**Submission of Layout Plan and Application for Commercial Development on IL No.8945 Causeway Bay, Hong Kong
under s16 of the Town Planning Ordinance (Cap.131)**

s.16 Planning Application No. A/H7/185 - Departmental Comments

Response to Comments

April 2024

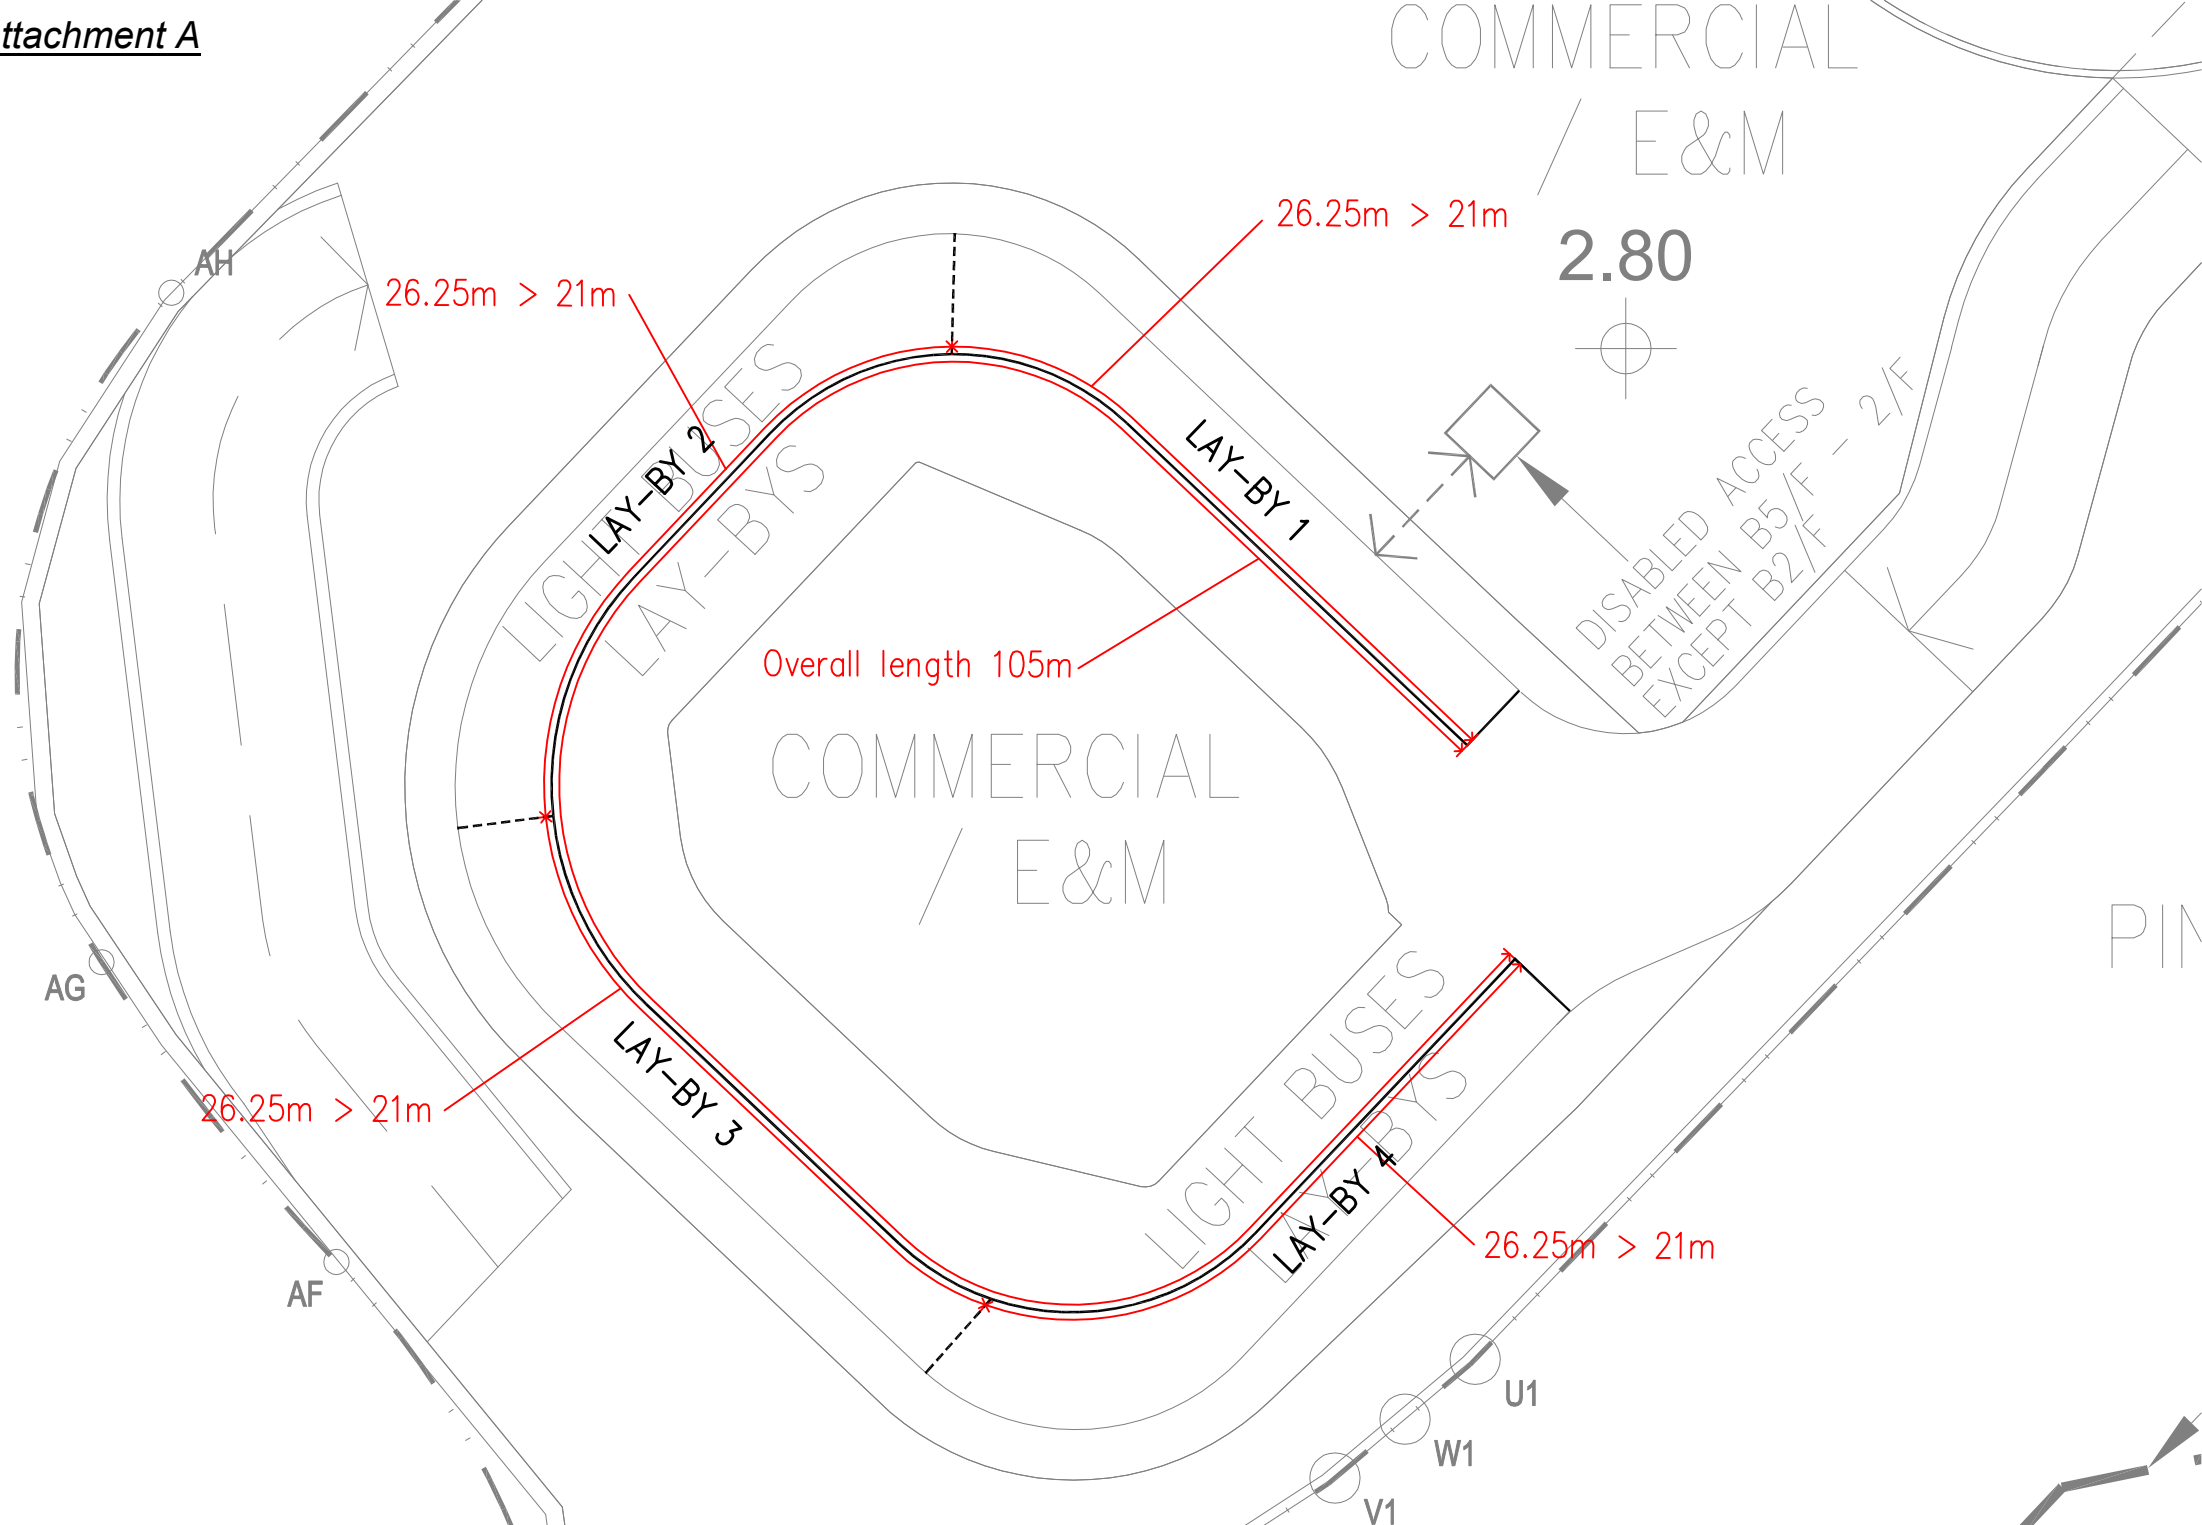
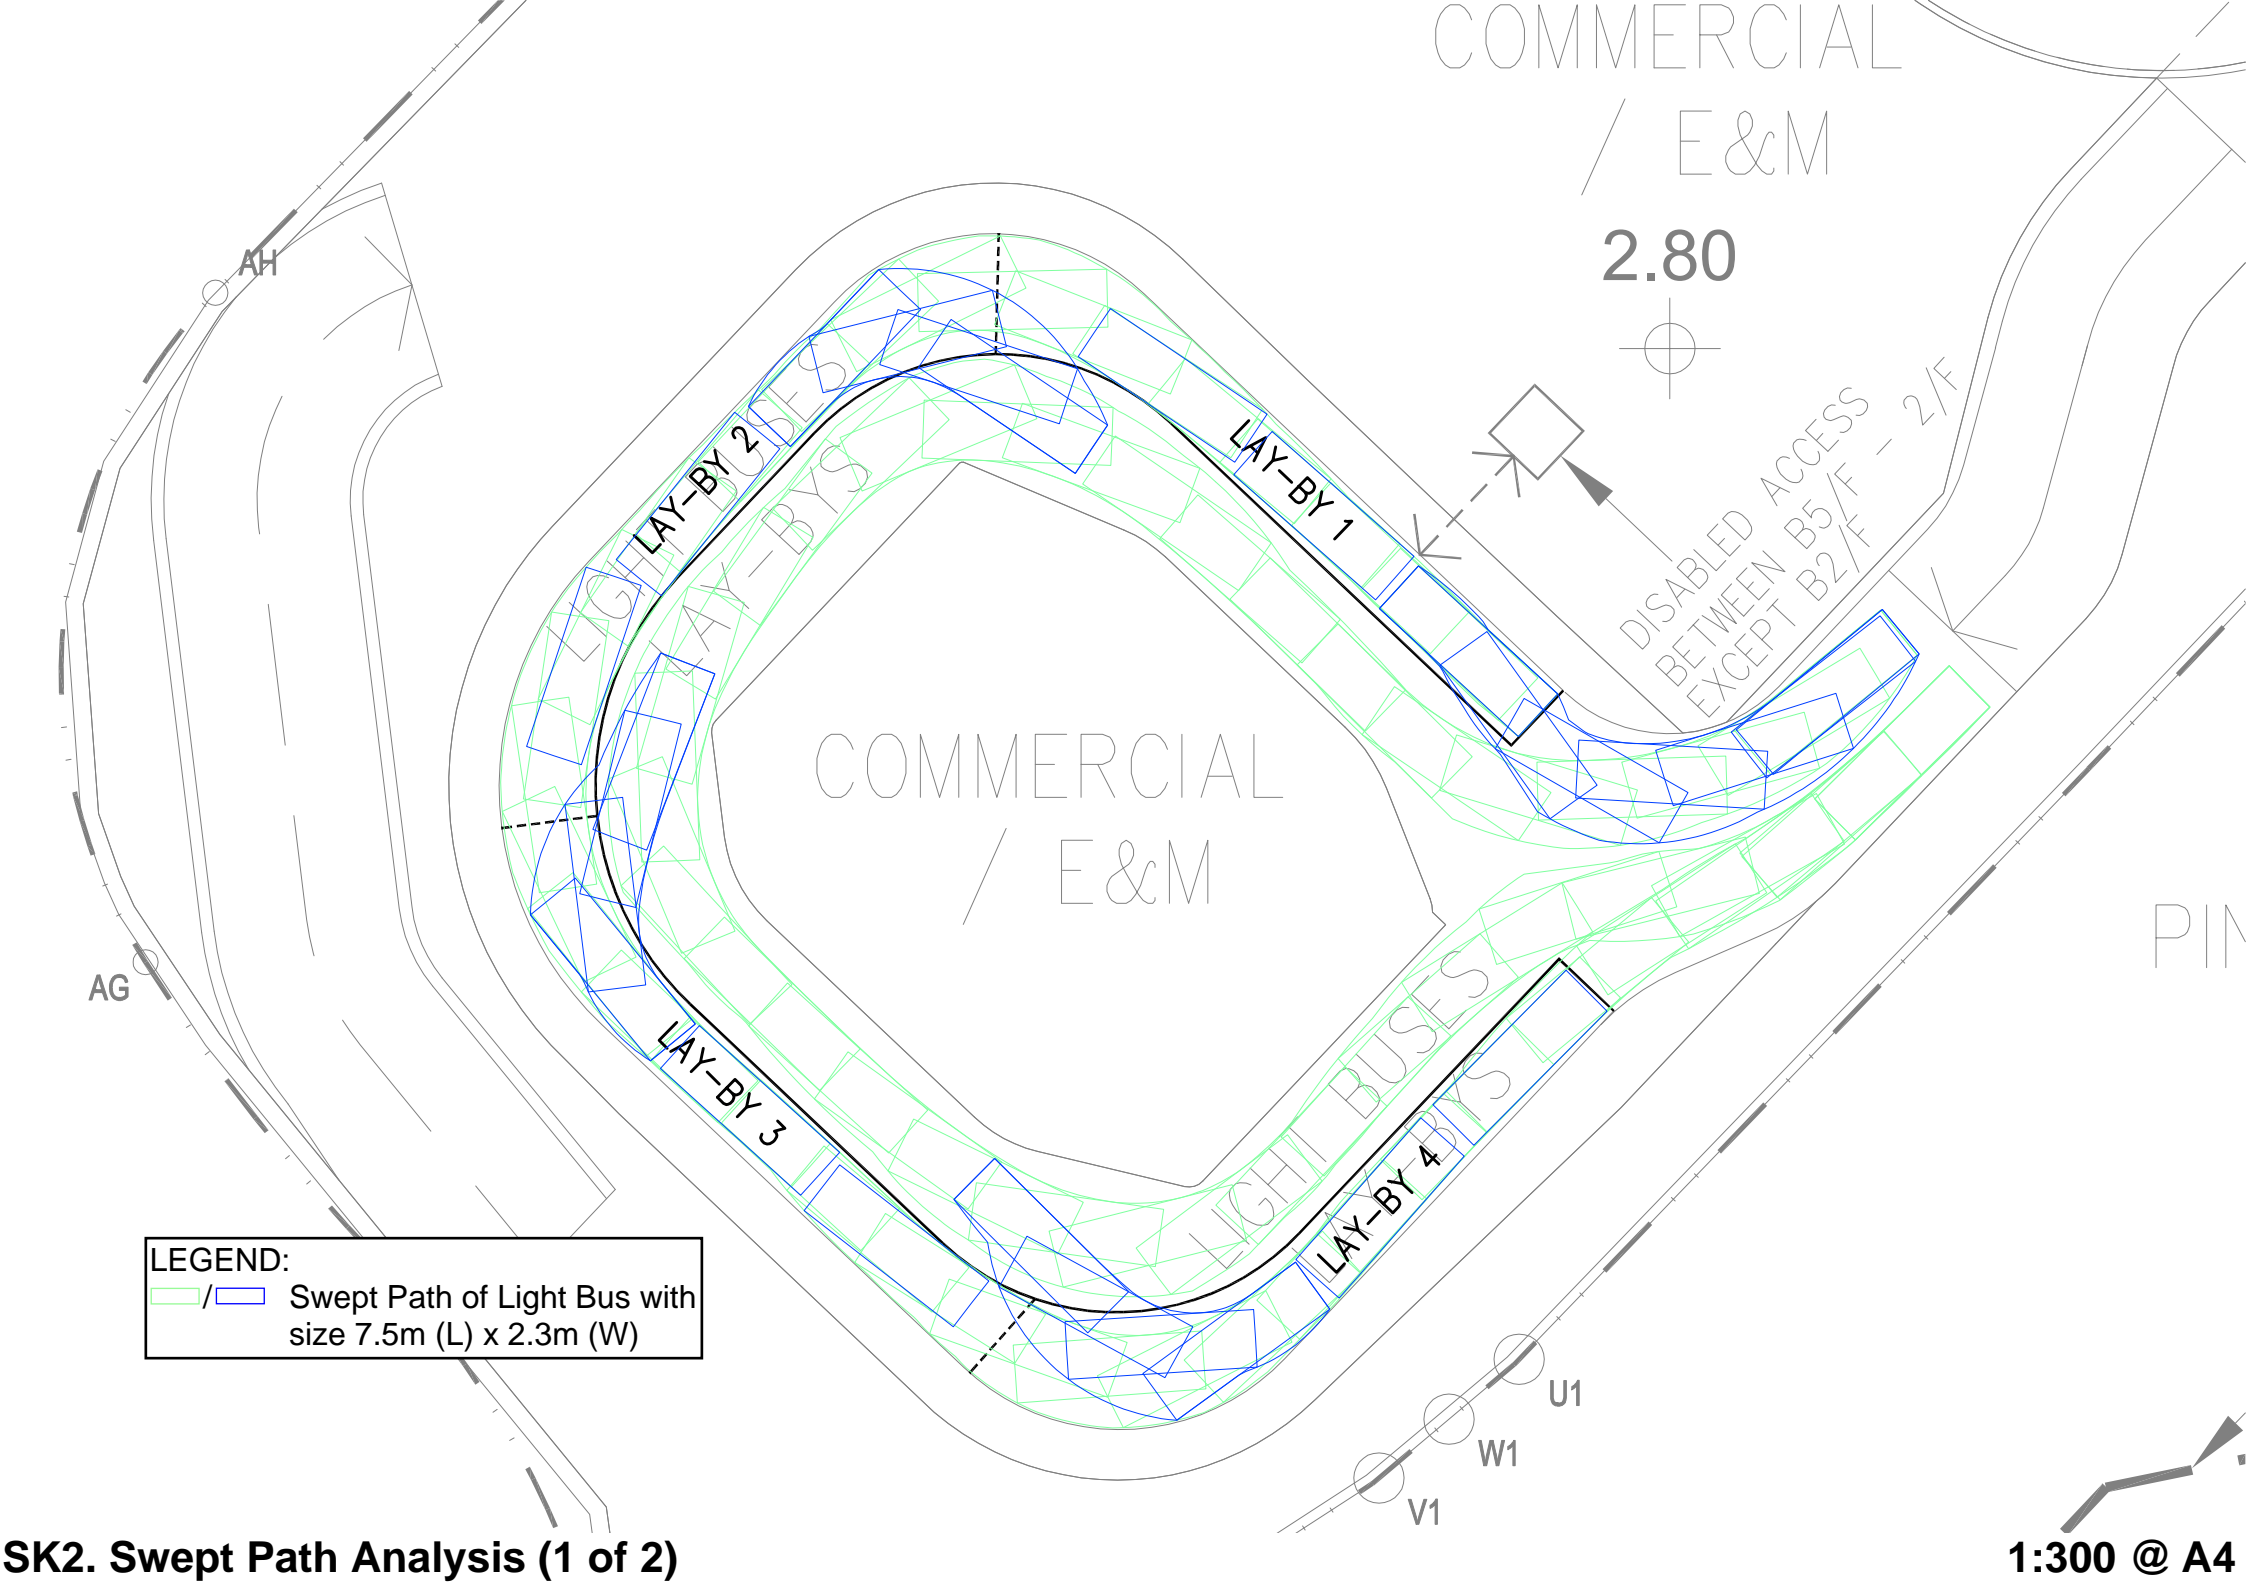
- As shown in Annex B (MLP-006), the vent shaft is proposed to be located adjacent to the OVT LANDS(LEASED) WCH/1 (HKP WCH/1). Please advise the vent shaft type, and if hot/warm air or strong air flow will be emitted from the vent shaft. Review on vent shaft location and whether the vent shaft operation will have adverse interference with the OVT's growth and health is recommended.

Please note that the vent shaft is located outside the Tree Protection Zone. Additionally, after coordination with the Architect and E&M consultant, the vent shaft has been relocated a further 2m away from the OVT. Furthermore, the design of the vent shaft ensures that emissions will not be directed towards the OVT (please refer to the image below).

This vent shaft is for basement carpark exhaust, the content of which is similar to that emitted from the vehicles passing by on Leighton Road abutting the OVT. Since the OVT has survived for many years beside this heavily trafficked road, we believe that it is unlikely this exhaust may potentially cause harm to the OVT. In addition, the exhaust will not be emitted continuously throughout the day but occasionally based on the temperature or CO content of the car parks.
